TTSH REV 3 ERRORS

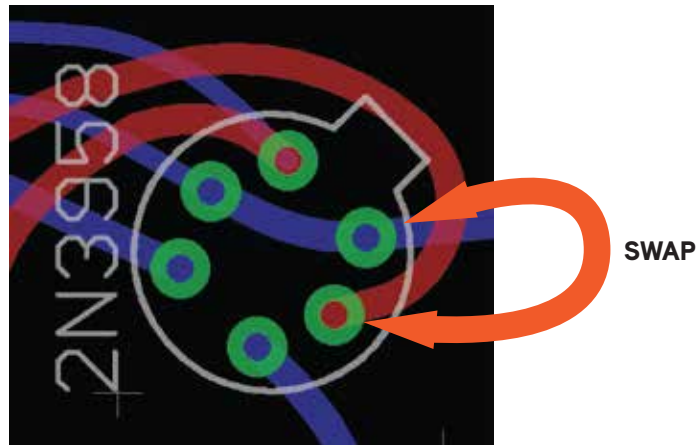
**DOUBLE FET HAS WRONG PINOUT! THIS IS FOR ALL 2N3954 AND 2N3958!
CROSS PINS 5 AND 6, SO IT LOOKS LIKE IT HAS TO GO TO THE BATHROOM.**

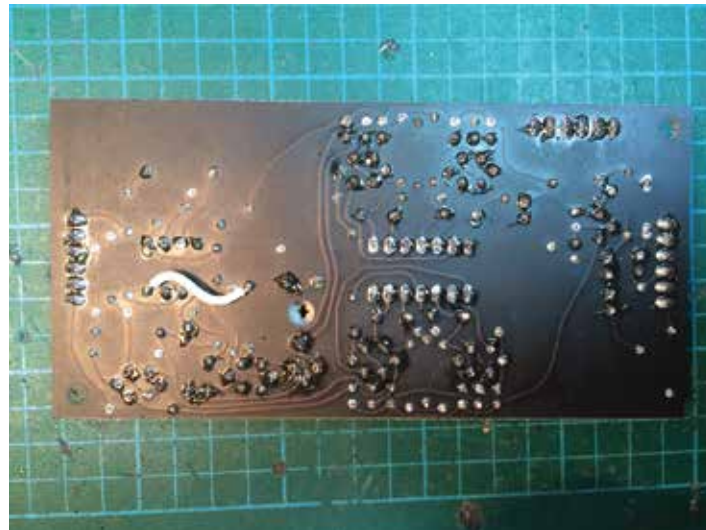
**MISSING TRACE – 4072 BOARD.
-14V IS MISSING FOR THE 1458 CHIP. JUMPER FROM NEARBY RESISTOR.**

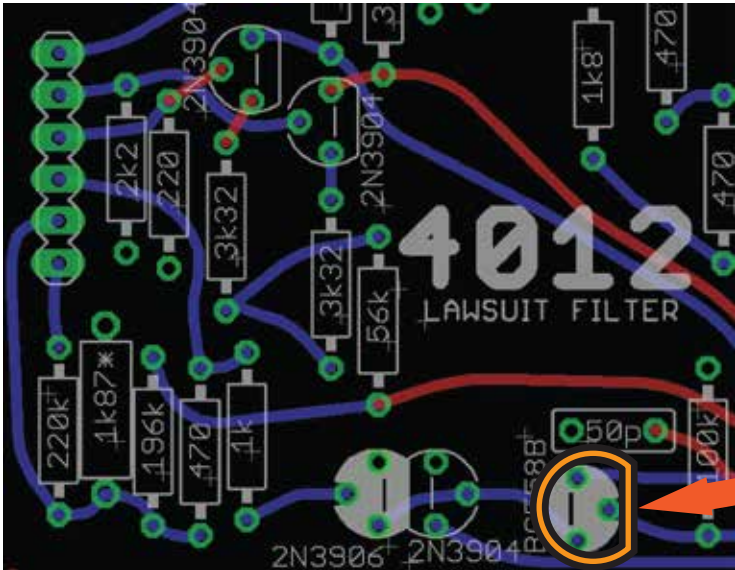
**MISSING TRACE – FILTER SECTION, MAIN BOARD.
V- IS MISSING IN HEADER FOR FILTER BOARD. JUMPER FROM POWER CONNECTOR**

THE BC558 LEGEND IS WRONG – INSTALL IT BACKWARDS ON 4012 FILTER BOARD

FLAT SIDE
FACING
THIS WAY
